WILLMORE ELEMENTARY SCHOOL

WESTMINSTER SCHOOL DISTRICT

WESTMINSTER CALIFORNIA

DEMOLITION FLOOR PLANS - A-B, C-D BLDGS

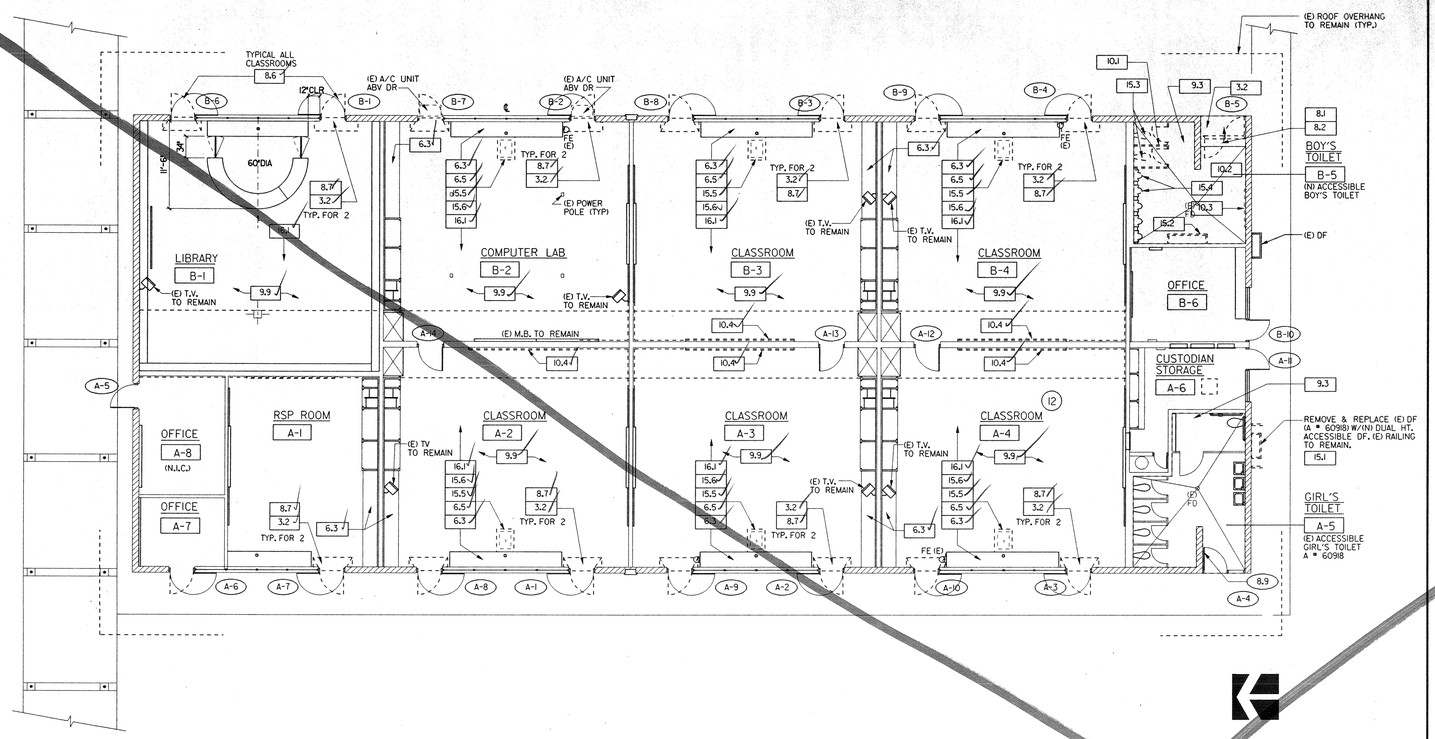
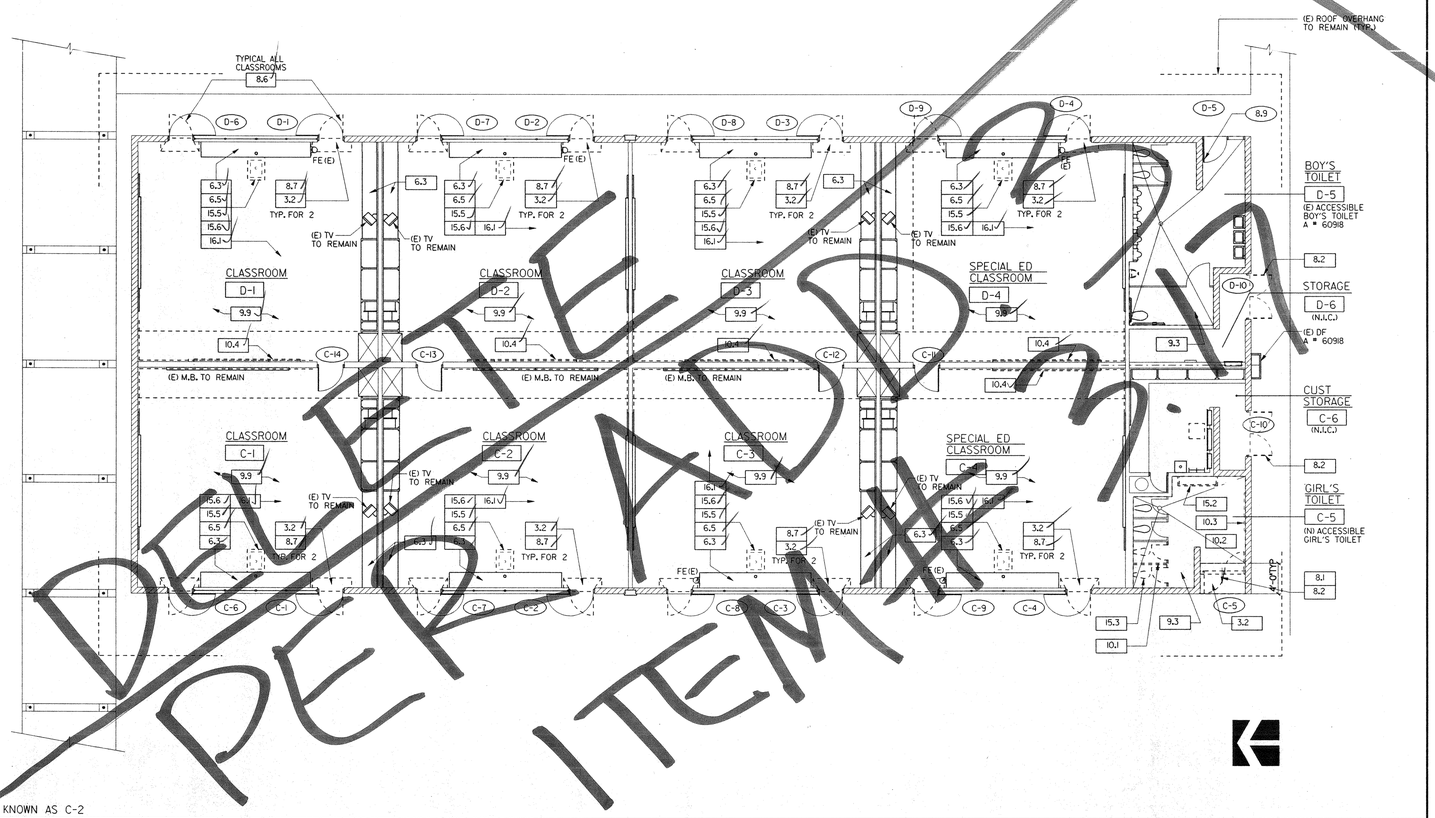
20. **ADDENDUM DRAWING AD3-3** is issued with this Addendum #3 to show the following:

a. At 'A-B' Bldg., Demolition Note 8.11 is added.

SHEET OF
AD3-03
(D-2.1)
REFERENCE

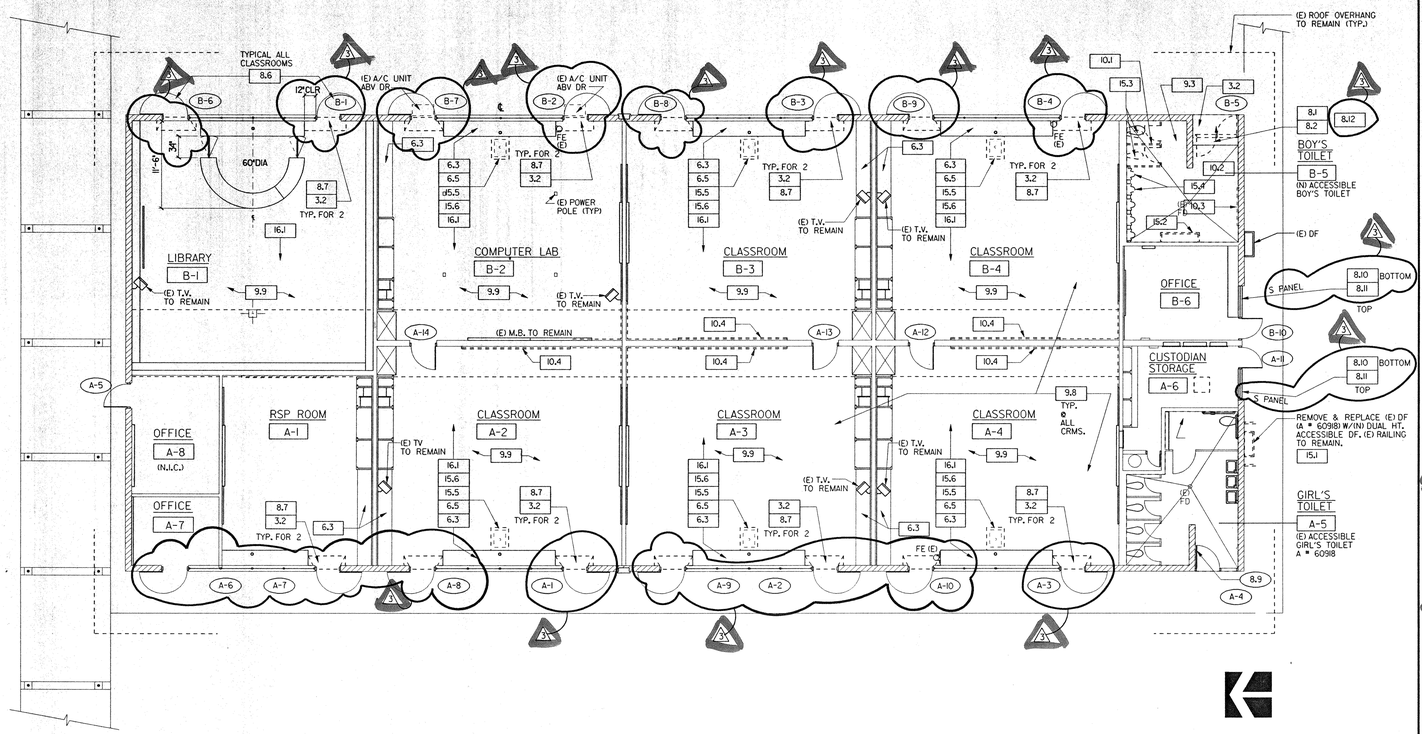
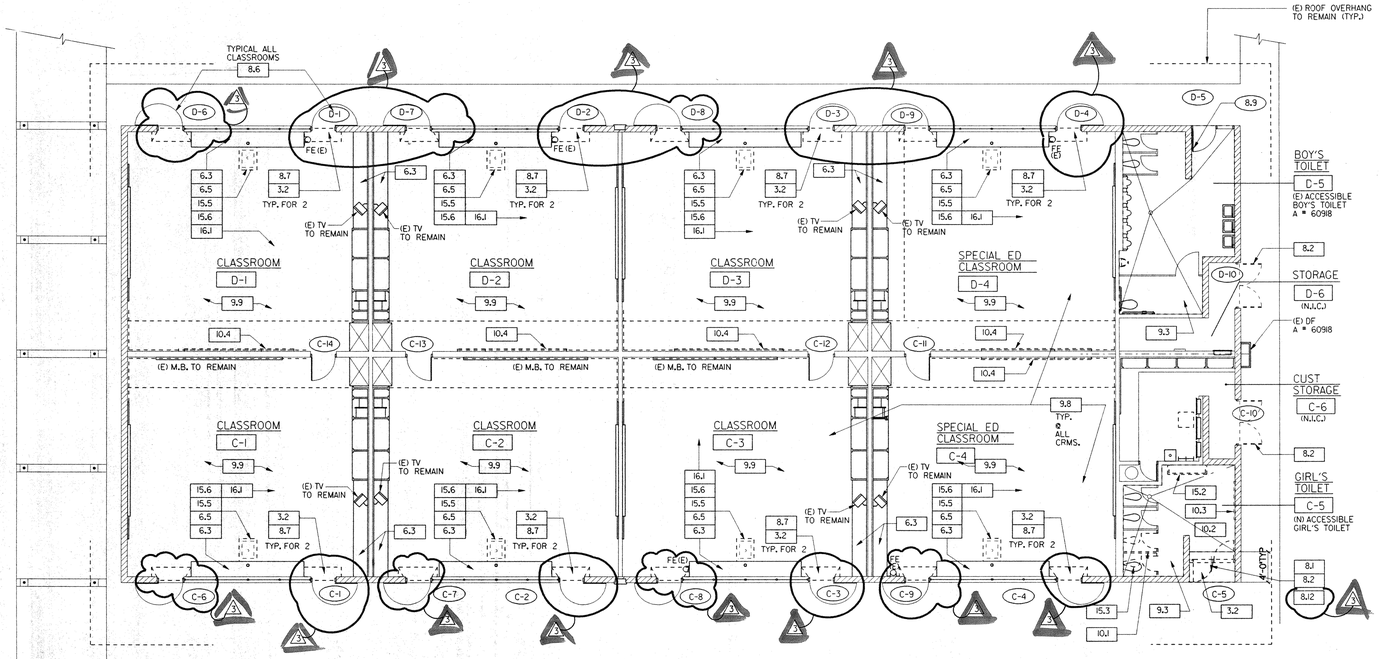
3.17 SHEET D-2.1 - DEMOLITION FLOOR PLANS - 'A-B' & 'C-D' BLDGS.

ACC. PASSENGERS DROP-OFF ZONE (5)

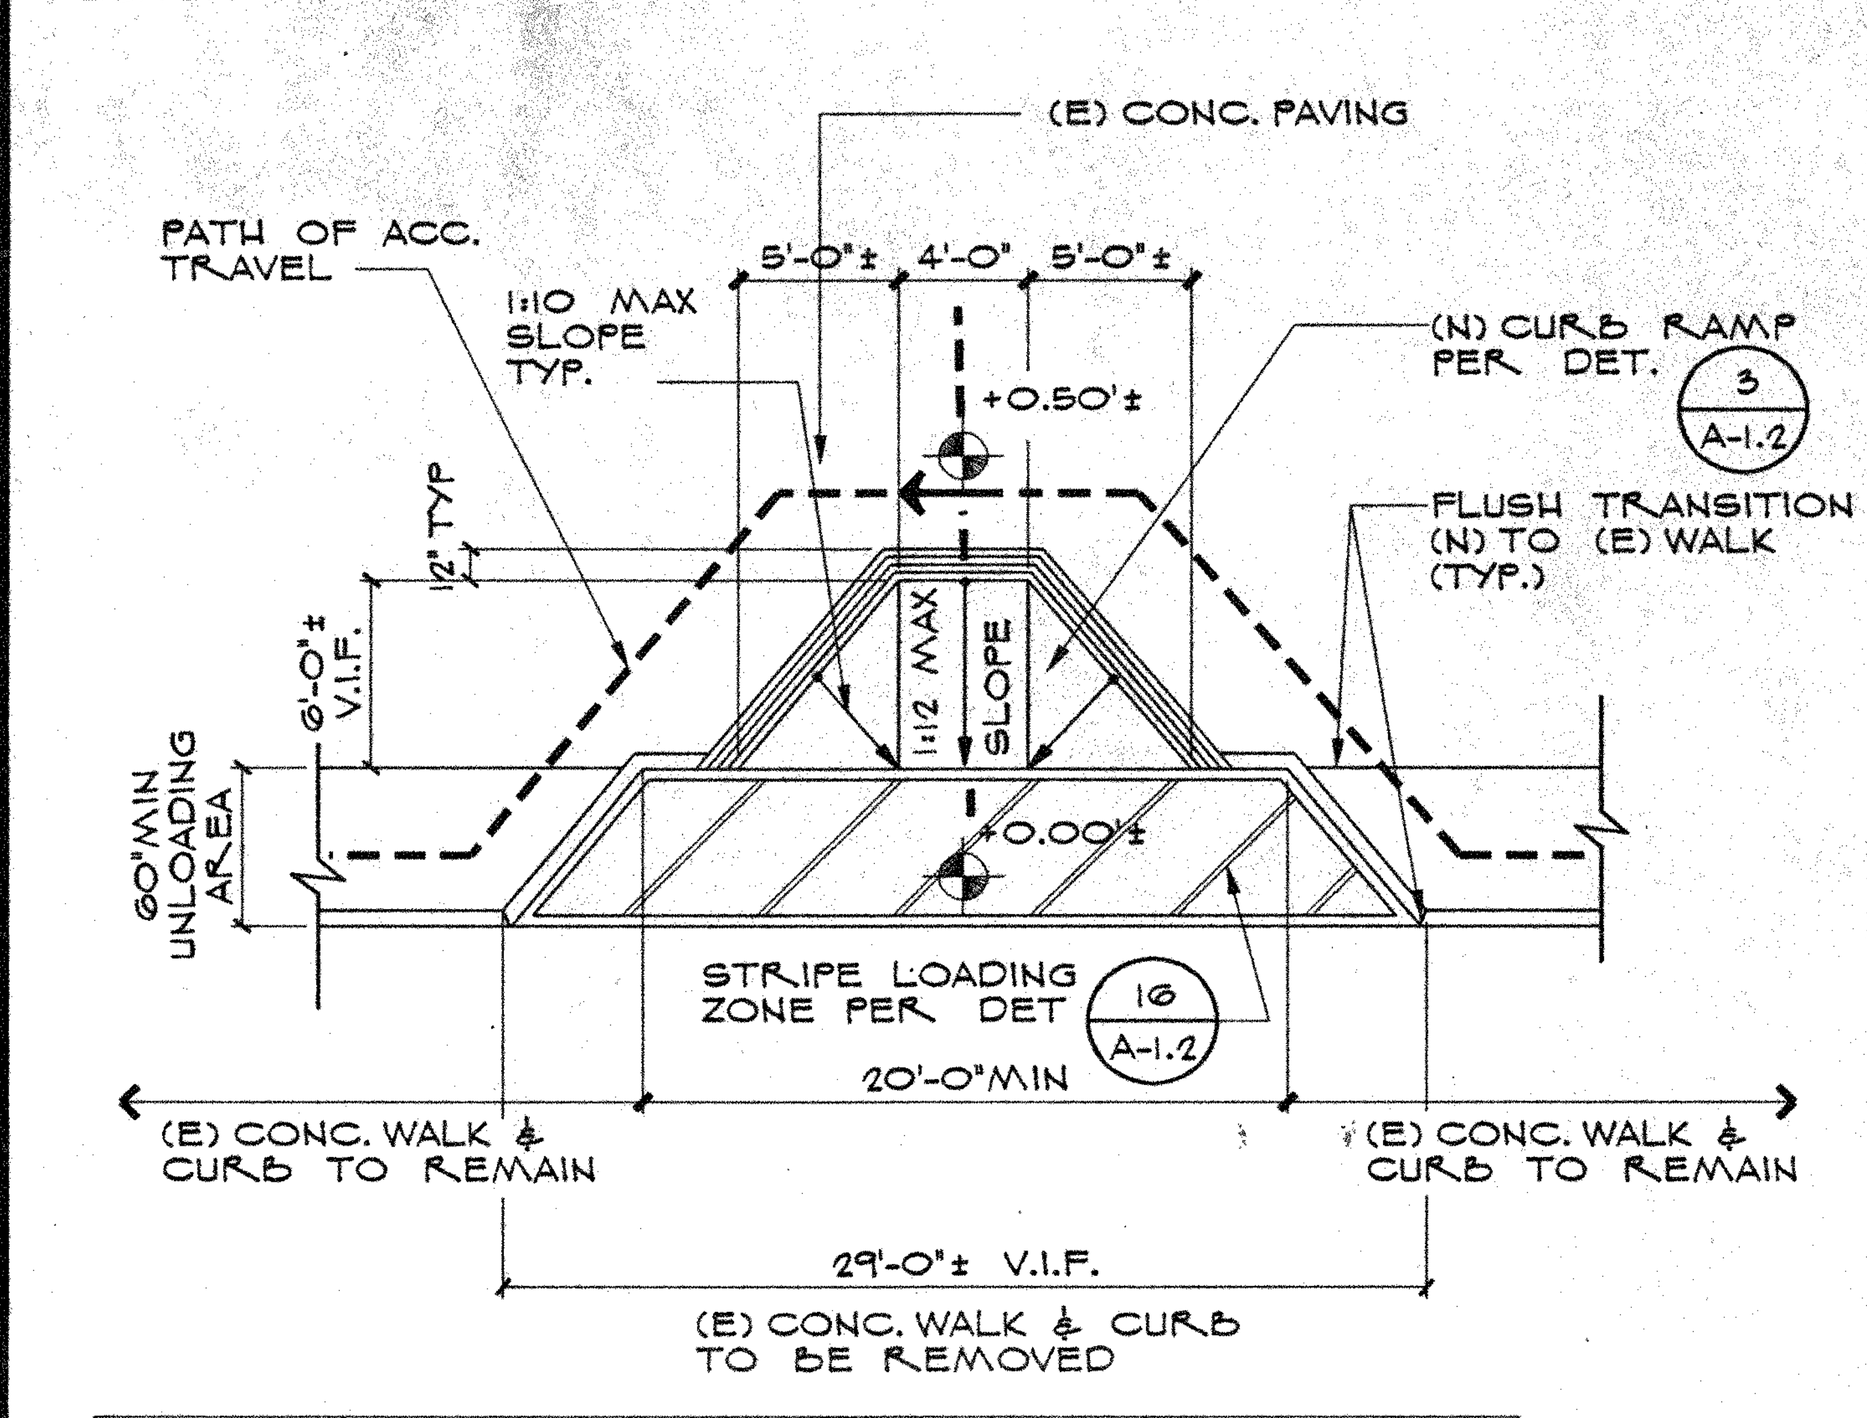
22. At Detail 5, after 'finish grade' note, ADD "and / or asphalt paving".

SHEET OF
AD3-04
(A-2.1)
REFERENCE

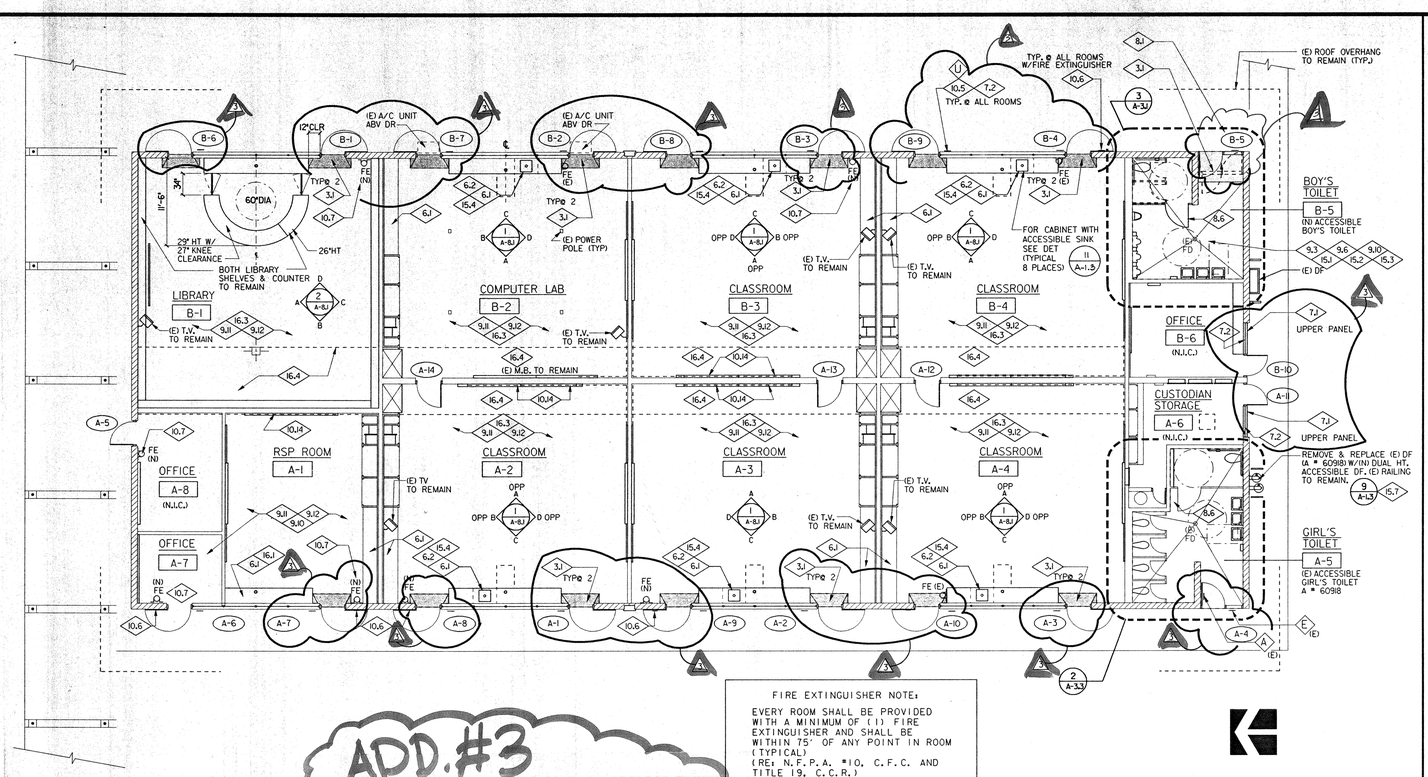
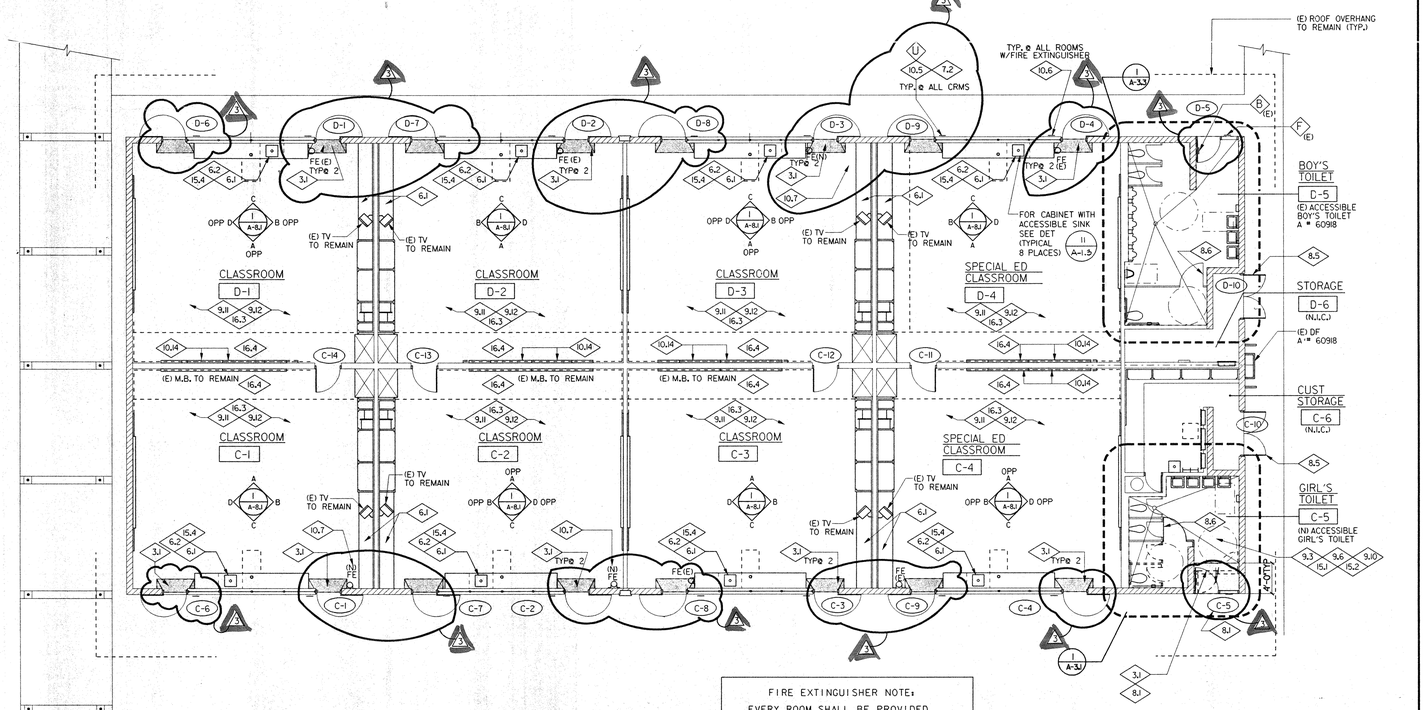
3.20 SHEET A-2.1 - FLOOR PLANS - 'A-B' & 'C-D' BLDGS.

24. **ADDENDUM DRAWING AD3-4** is issued with this Addendum #3 to show all exterior classroom doors swing back to existing.

ENLARGED TOILET PLAN – BOYS TOILET B–5 – BLDG "A–B" | SCALE 1/4" = 1'-0" | 3

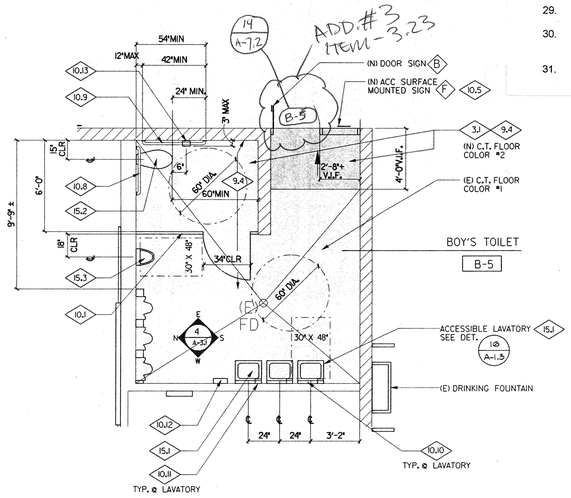
29. At Detail 3, CHANGE door swing from outside to inside bldg.

31. At No. 3, at Exterior Door B-5, ADD Detail reference "14/A-7.2" to floor.

ENLARGED TOILET PLAN – GIRLS TOILET C–5 – BLDG. "C–D" | SCALE 1/4" = 1'-0" | 1

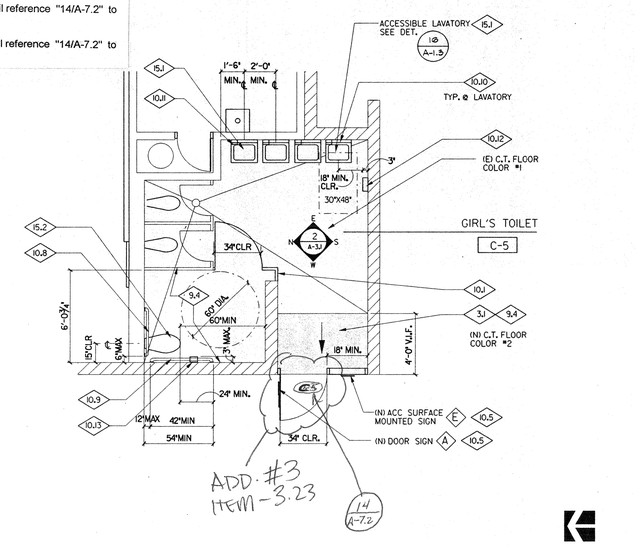
28. At Detail 1, CHANGE door swing into bldg. from outside.

30. At No. 1, at Exterior Door C-5, ADD Detail reference "14/A-7.2" to floor.
